REMARKS

The Rejections:

Fig. 2

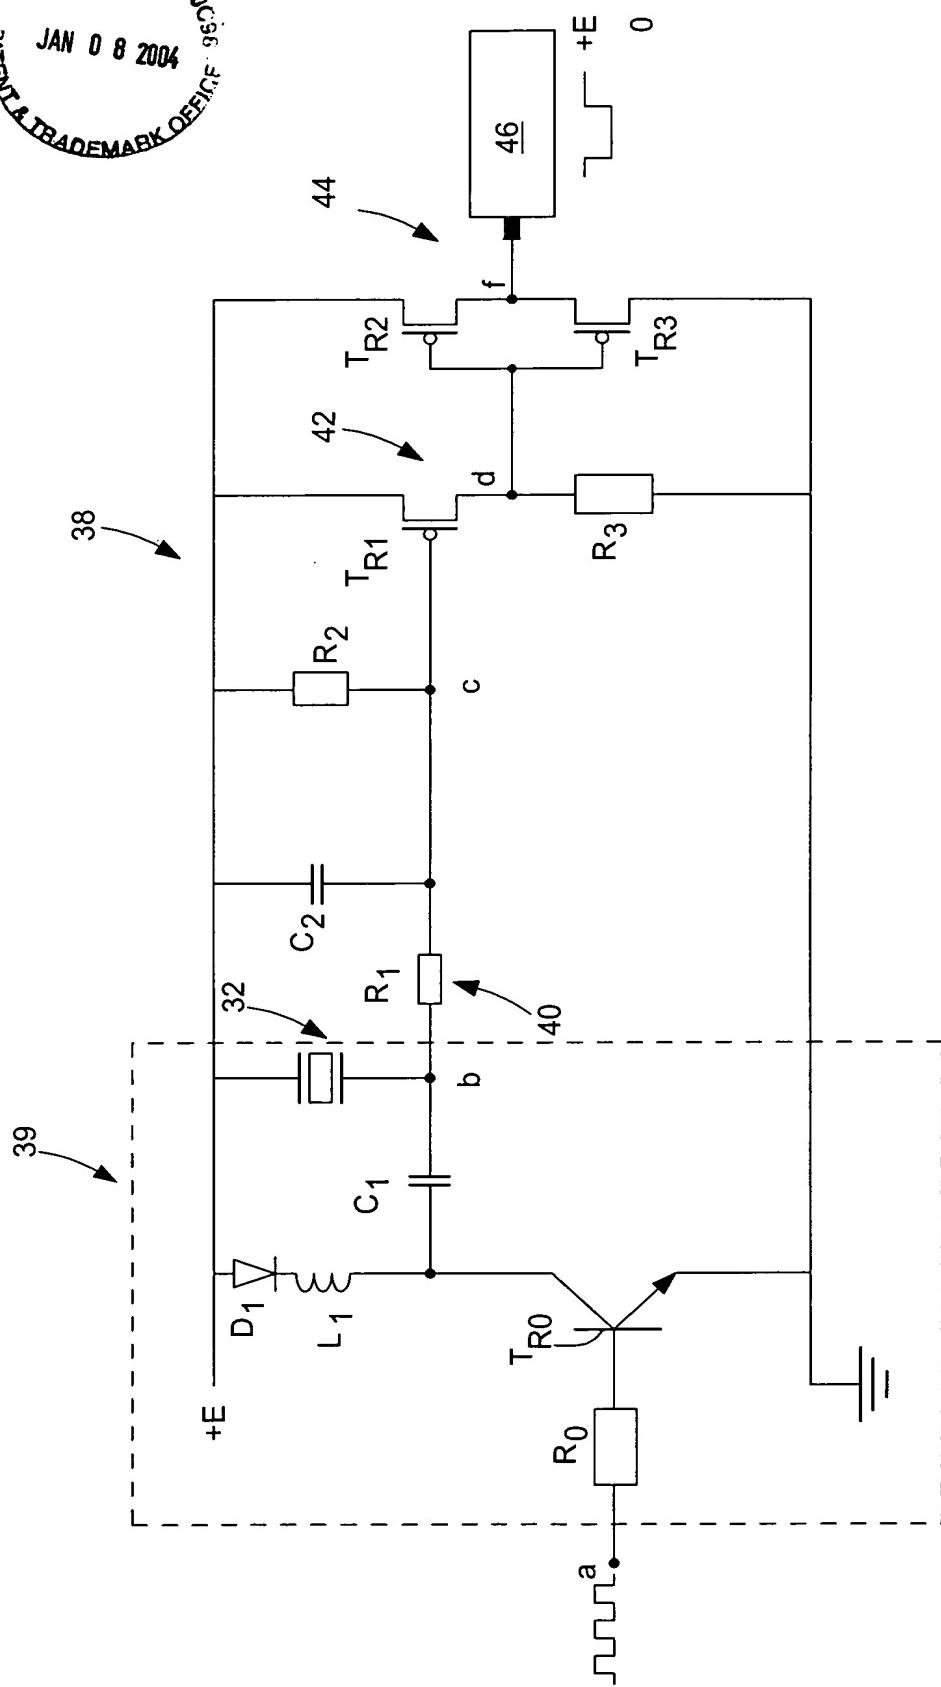
The drawings stand objected to under 37 C.F.R. 1.83(a), for failing to disclose the microprocessor, the second electronic circuit, and the diode. The amended Fig. 2 is believed to overcome these objections and withdrawal of the rejection is respectfully requested.

Fig. 2 has been amended, as discussed above, to include new drawing Fig. 2 includes a box referenced 46 located at connection point "f" that comprises the output of conversion stage 44. This amendment is supported at page 8, lines 12-15 of the specification. Line 15 of page 8 of the specification has been amended accordingly. Amended Fig. 2 also includes a diode designated by D₁ has also been represented on new drawing figure 2, this diode being mounted in series with coil L₁. This amendment is supported at page 5, lines 32-34 of the original specification. Line 33 of page 5 of the specification has been amended accordingly.
